HISTORIC DISTRICT COMMISSION
STAFF REPORT

5:30 pm • July 25, 2018 • City Hall

C1 NEW SINGLE FAMILY RESIDENCE - 2113 WEEMS STREET

**ROBINSON HISTORIC DISTRICT
CERTIFICATE OF APPROPRIATENESS REVIEW
NEW SINGLE FAMILY RESIDENCE
815 MITCHELL STREET**

Site Plan

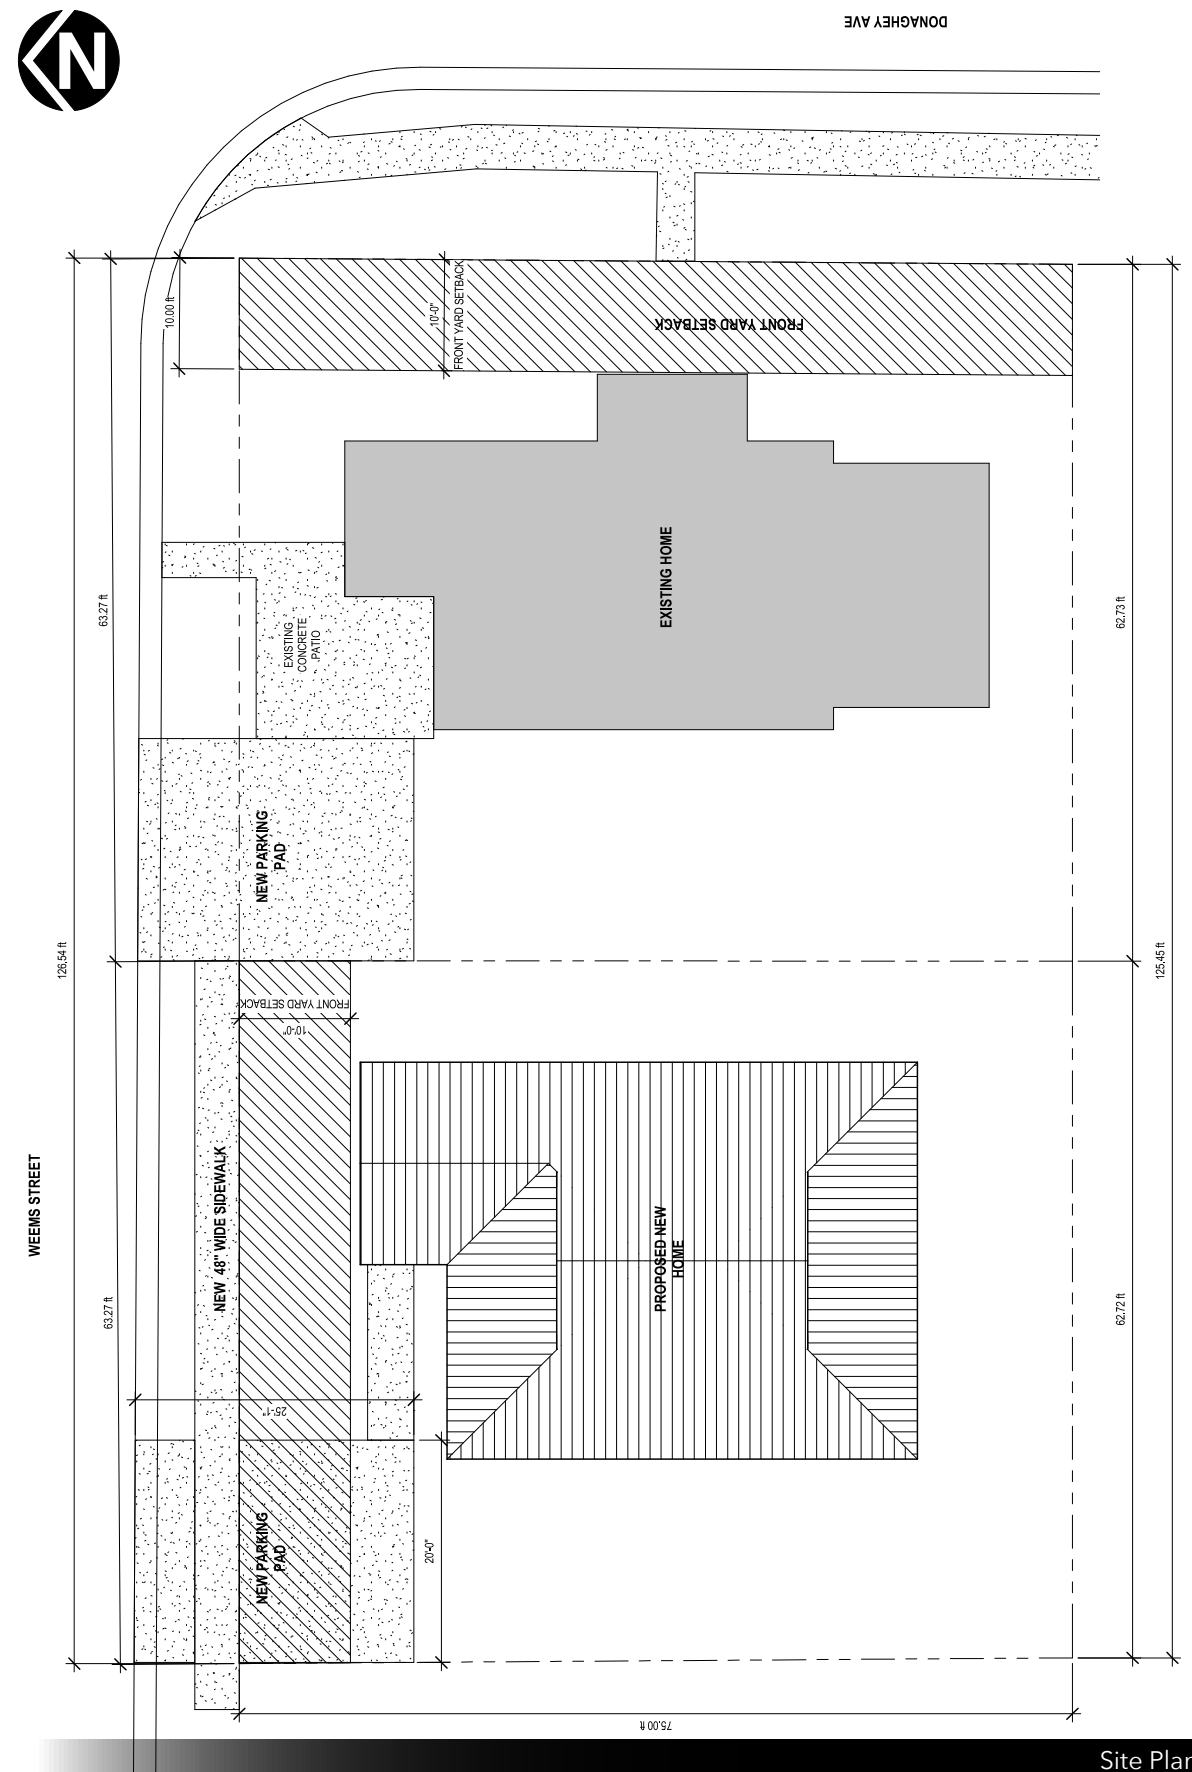
Setbacks. Proposed setbacks should respect the predominant setbacks of area structures, especially the front setback. Front setbacks are allowed within a range of 85% to 115% of the average area front setback. The average area setback from the property line is 18'. The proposed front setback is 11'-6". The maximum allowed front setback is 21 feet while the minimum is 15 feet. The proposed front setback of around 11 feet under the minimum. An average of the 2 abutting residence's setbacks is 15 feet. The west side setback is around 18 feet and the east side setback is around 10 feet. The rear is shown at around

15 feet. The side setbacks are appropriate. The front setback should be increased to 13 feet to get closer to the minimum average. This would decrease the rear setback to 13 feet.

Doors and windows. Doors and windows have a traditional vertical form. Windows on all elevation except the south have mullion dividers creating two over two windows. Simple one over one windows could be more appropriate than windows with false dividers.

Roof. Although illustrated as metal standing seam roofing, the roof is noted as asphalt shingle.

1. The residence shall be constructed as shown in submitted plans.
2. The residence's front setback shall be approximately 13 feet from the property line.

3. Driveway parking pads and interior sidewalks shall be concrete and located as shown on site plan.
4. Porch columns shall be a trimmed out to approximately 8 inches by 8 inches minimum.

5. Floor to ceiling height shall be 9 foot minimum.
6. Siding material shall be fiber cement board with a brick wainscot.
7. One over one windows are preferred rather than windows with false dividers

8. HVAC and utility equipment shall be appropriately located at the rear or side of the structure and/or appropriately screened.
9. A new 4 foot wide sidewalk shall be constructed along Weems Street on the newly created lot or an in-lieu fee of \$504 shall be paid. The sidewalk construction or in-lieu fee must take place prior to issuance of a certificate of occupancy for the new residence.

Site Plan

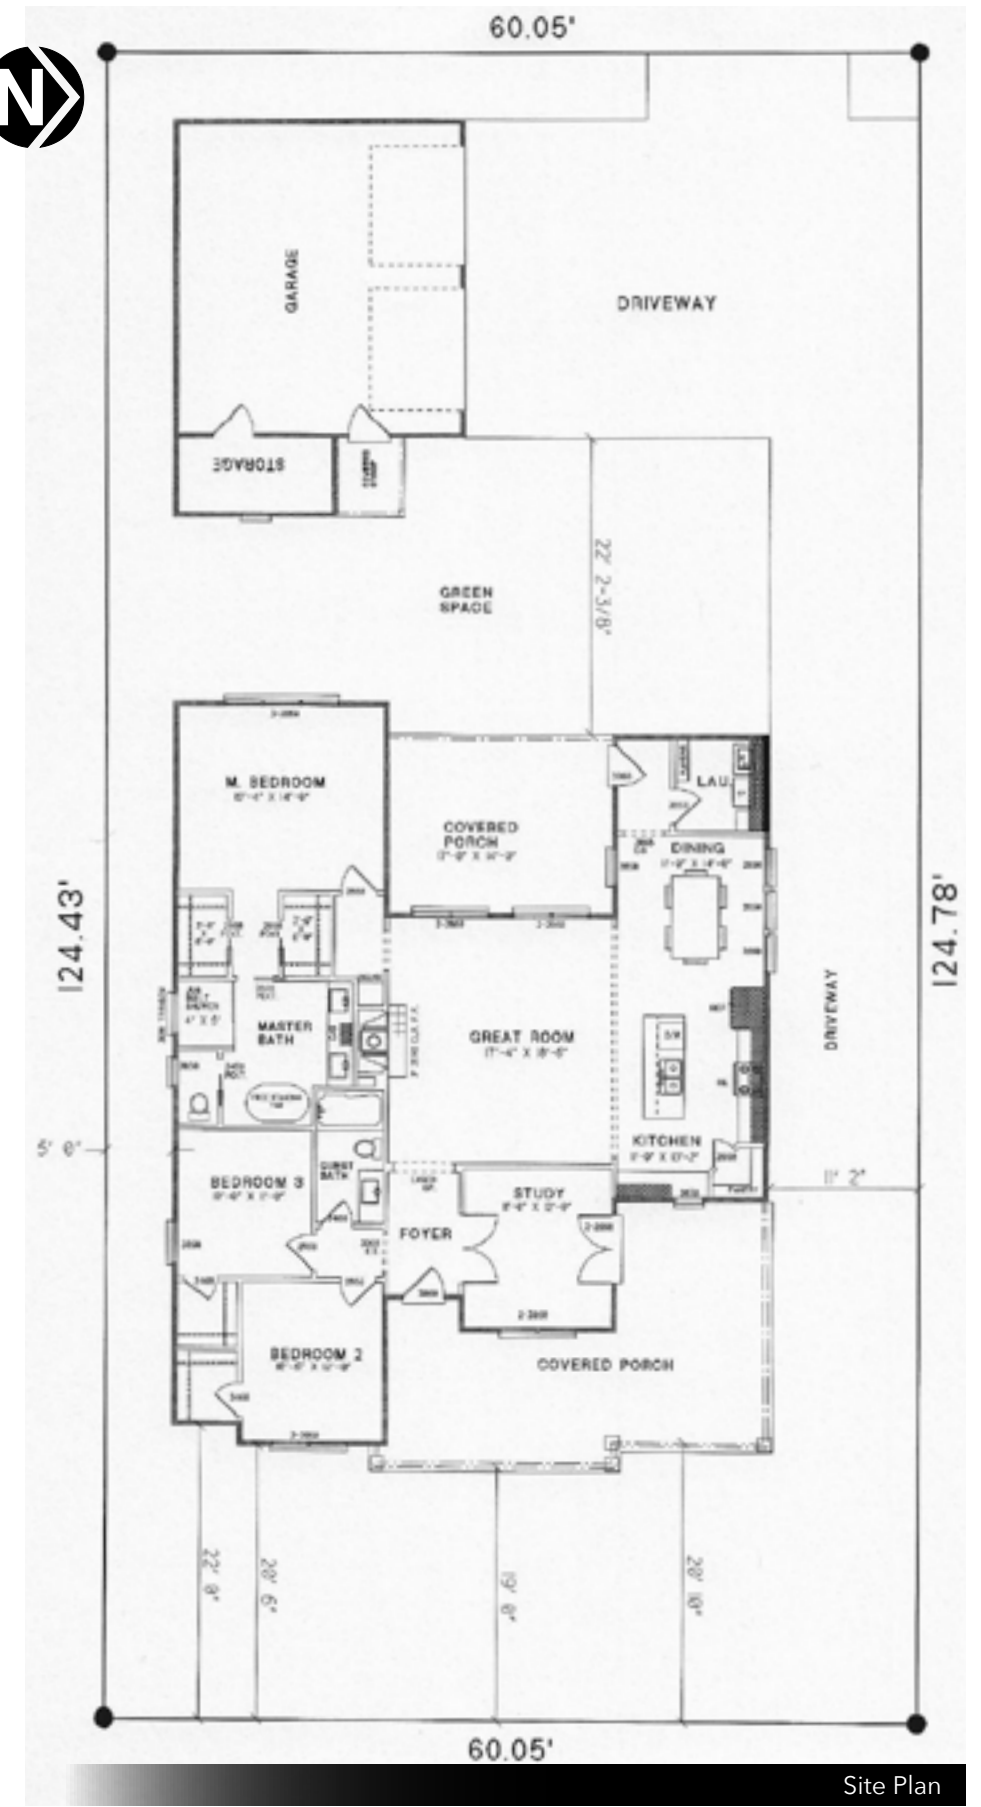
Setbacks. Proposed setbacks should respect the predominant setbacks of area structures, especially the front setback. Front setbacks are allowed within a range of 85% to 115% of the average area front setback. The average area setback from the property line is 24 feet. The proposed front setback is 19 feet from the property line. The appropriate front setback range is 20-27 feet. The requested front setback is 1 foot under the minimum. The side setbacks are 5 feet on the south and 11'-2" on the north. The home's rear setback is around 47 feet. The outbuilding is set at 5 feet from the rear and south side and 22'-3" from the house. Side setbacks for the residence and garage are appropriate for the lot and area.

Tree preservation. There is a 24"+ hackberry tree that appears to be in the center of the proposed driveway. The hackberry has been somewhat "hacked" by utility tree trimmers. There are existing overhead power lines. A remedial understory tree could be planted between the sidewalk and the new residence.

1. The residence and garage shall be constructed as shown in submitted plans.
2. The residence's front setback shall be approximately 19 feet from the east property line.
3. An understory tree with a minimum 2" caliper shall be planted to remediate removal of the large hackberry tree.
4. Floor to ceiling height shall be 9 foot minimum.
5. Siding material shall be fiber cement siding such as Hardie board or similar.
6. One over one windows may be used in lieu of false window dividers.

Front Elevation

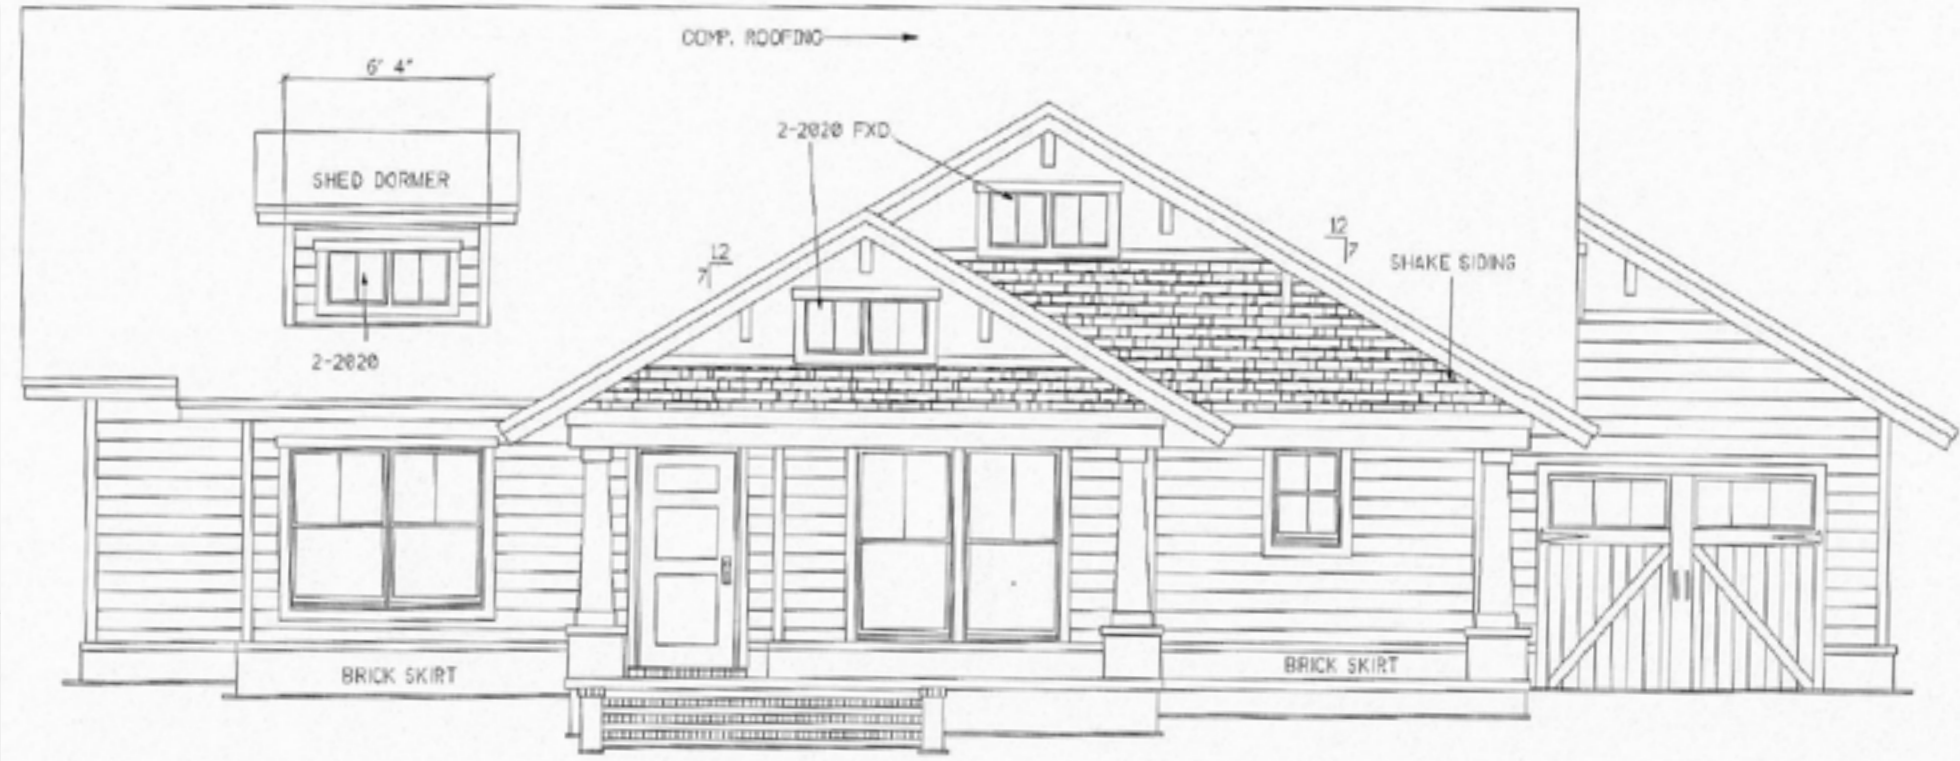
Doors and windows. Windows are shown with muntin dividers creating mostly two and two over two windows. Simple one over one windows would be more appropriate than windows with false dividers.

7. Wide trim around windows and doors and mixture of roofing shall be used as shown.
8. Driveway shall be 10 feet wide concrete driveway accessing the rear garage and turn around area.
9. HVAC and utility equipment shall be appropriately located at the rear or side of the structure and/or appropriately screened.
10. Any damage to the sidewalk during construction shall be repaired.

photo of actual freestanding carport

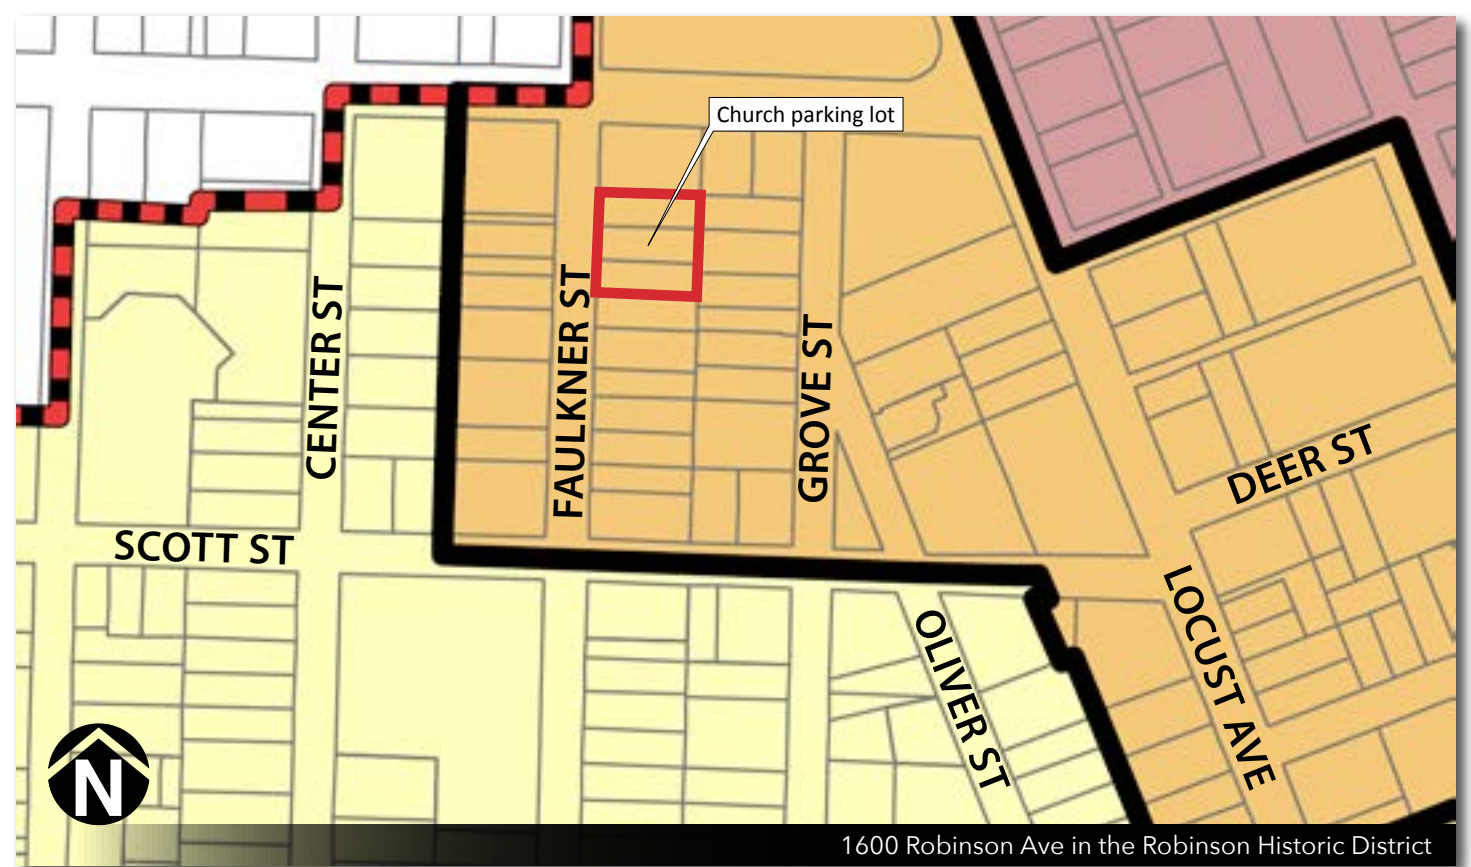
Scale. The size of new construction in relation to neighboring structures and the proportion of structures to the human scale. The van cover is 45 feet long by 24 feet wide and 13 feet tall. It covers 1080 square feet. This is quite large as an accessory structure. Some area homes are almost this size. The van cover constructed by the Church of the Nazarene one block south covers 720 s.f. The Church of the Nazarene cover is in the Old Conway Design Overlay.

The proposed cover is a utilitarian structure that is basically a metal roof. The structure is not traditional in nature or constructed of traditional materials.

Location 1 places the cover farther from Faulkner and Robinson and the public view. However, in order to place the cover at this location, recently constructed drive aisles, green spaces, and trees would have to be removed. There is a 24”+ American Elm and 30”+ Hackberry.

Location 2 is close to Faulkner Street. The “open” end of the cover would face Faulkner. Vehicles would enter and exit the cover from the open end on the east side. The low metal panel currently visible from Faulkner Street would be placed on the south side of the cover. The existing green space islands near Location 2 have no landscaping. Landscaping could be required in order to better screen the cover from public view.

Staff recommends that Location 1 not be approved due to tree removal and possible conflict with storm water drainage.

1. The van cover shall be located at proposed Location X.
2. The dead tree on the west end of the new parking lot expansion shall be replaced with a new 2” caliper tree of the same species.

3. Remedial canopy trees 2” caliper minimum shall be planted at 30 feet on center along the Faulkner Street frontage.
4. A contiguous hedgerow, 30” at the time of planting shall be added to the Faulkner Street frontage.

3. (2) canopy trees 2” caliper minimum shall be added to the vacant green spaces. One on either side of the south parking lot entry.
4. An evergreen hedge row with a minimum height at time of planting of 30” shall be added to the south green space abutting Location 2 to screen vehicles.
